Access Compliance Report

Public Rights-of-Way

Intersection ID: 12695	Main Street: S_CALDWELL_ST	Cross Street: E TRADE ST	Location: E
ADA ID: 6BABF16206C3	Ramp Type: Perp	Initial Pass/Fail: Fail	Overall Compliance: No
Severity Score: 12.5			
Codes/Mitigation Info/Possible Solution		Field Measurements/Component Compliance

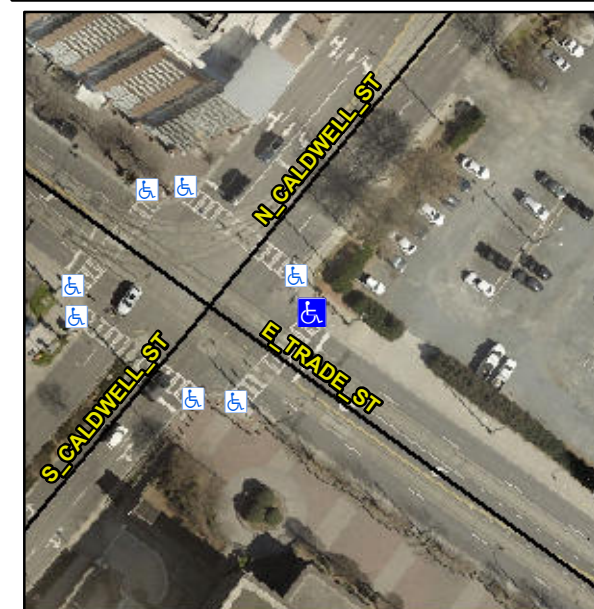
R304.2.2

Compliance	Description	Data	Compliance	Description	Data
N/A	Ramp Length (in)	72.0	No	Ramp Slope (%)	8.4
Yes	Ramp Width (in)	48.0	Yes	Ramp XSlope (%)	1.3
N/A	Flare Type LT	N/A	N/A	Flare Type RT	N/A
N/A	Flare Slope LT (%)	N/A	N/A	Flare Slope RT (%)	N/A
N/A	Flare Traversable LT?	N/A	N/A	Flare Traversable RT?	N/A
N/A	Landing Length (in)	N/A	N/A	DWS Provided?	N/A
N/A	Landing Width (in)	N/A	N/A	DWS Contrast?	N/A
N/A	Landing Slope (%)	N/A	N/A	DWS Length (in)	N/A
N/A	Landing X Slope (%)	N/A	N/A	DWS Full Width?	N/A
N/A	Landing Curb? (Y/N)	N/A	N/A	DWS Offset (in)	N/A
N/A	Shared Landing?	N/A			
N/A	Gutter Ponding?	N/A	N/A	Gutter Slope (%)	N/A
N/A	Gutter Lip Ht (in)	N/A	N/A	Gutter X Slope (%)	N/A
N/A	Painted X Walk1?	Yes	N/A	Painted X Walk2?	N/A
	X Walk 1 Direction	To SW		X Walk 2 Direction	N/A
N/A	X Walk 1 Width (in)	121.0	N/A	X Walk 2 Width (in)	N/A
	X Walk 1 Slope (%)	3.1		X Walk 2 Slope (%)	N/A
	X Walk 1 X Slope (%)	0.2		X Walk 2 X Slope (%)	N/A

Remove & Replace Entire Ramp.
